Westinghouse
Electric Corporation

DCP/NRC1245
NSD-NRC-98-5556
Docket No.: 52-003

SUBJECT: AP600 RESPONSE TO FSER OPEN ITEMS

Figure 720.425F-1

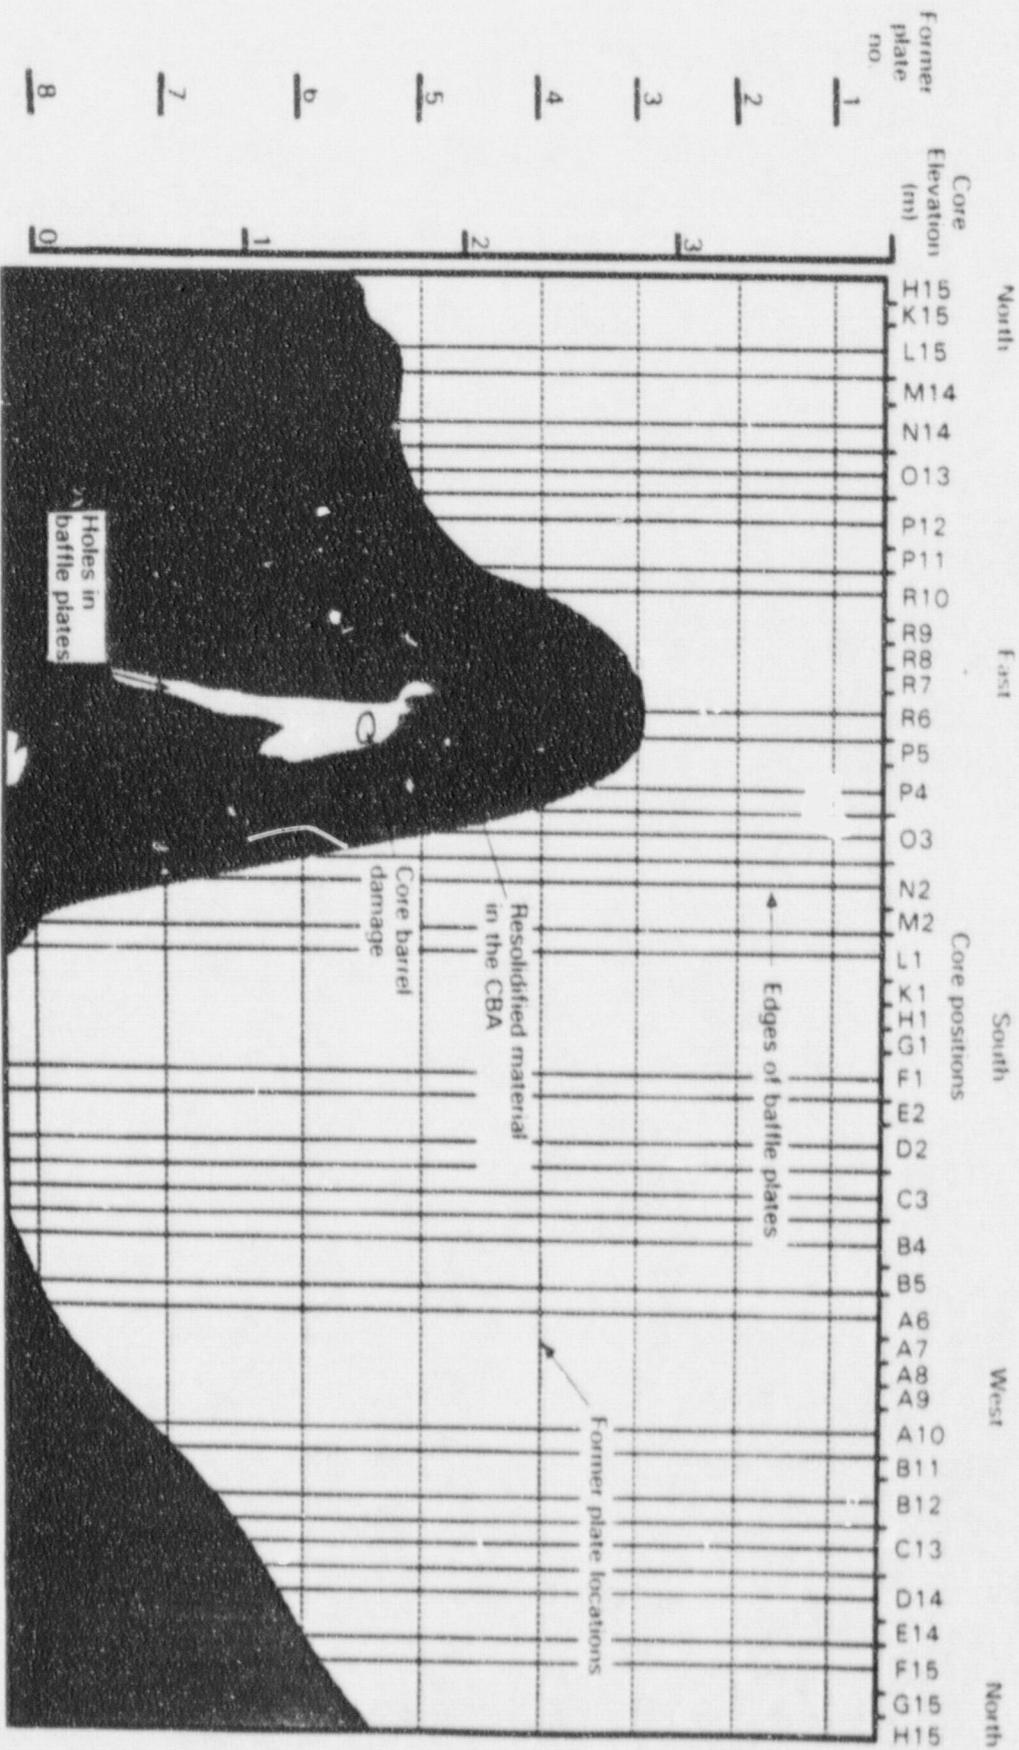
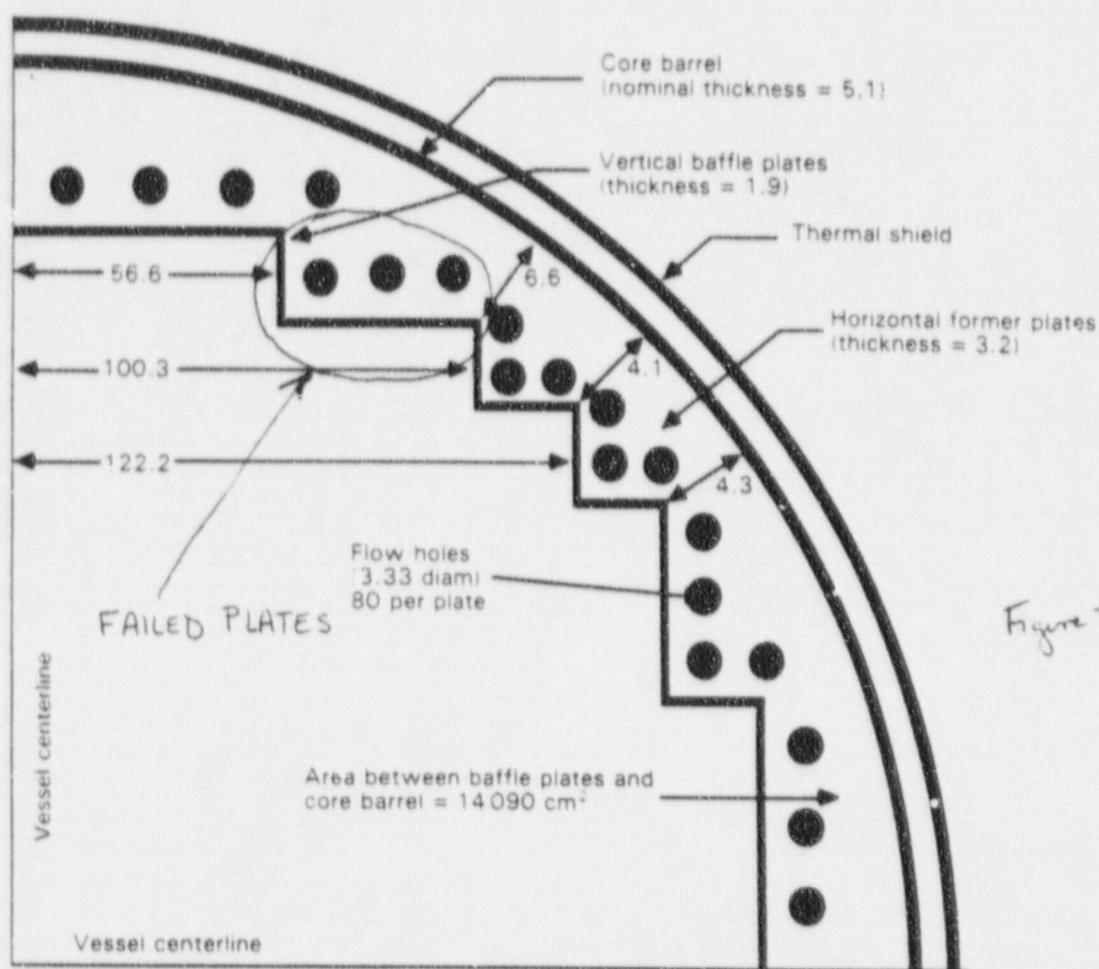
During the open item closure meeting on January 22, 1998, the staff requested additional information be supplied to the response of this FSER open item. Specifically, the staff's comments were as follows: the discussion of the initial reflector melt-through area does not include a justification to support the statement that the TMI-2 melt-through area was smaller than that used in the ROAAM. The statement that the growth of the hole was gradual over the duration of the pour does not appear to be consistent with the final hole size. Please support the statement that the ROAAM initial melt-through area is conservative with respect to the TMI-2 baffle failure size.

- d) It is also interesting to examine in more detail what the final hole on the TMI-2 baffle was really found to be. It is widely mentioned, as in the NRC question itself, that this hole is ~50 x 150 cm in horizontal and vertical dimensions respectively. Actually, as seen in Figure 720.425F-1, this is highly misleading. For more than half of the vertical distance, the hole is actually less than 20 cm. Also, the hole is narrower near the top, a little more than 20 cm, and it grows in lateral dimension for a distance of ~50 cm. Then it abruptly decreases to less than 20 cm. Finally, the baffle plates in Figure 720.425F-1 are shown "unfolded", while the true azimuthal size of the hole can be seen with the help of Figure 720.425F-2.
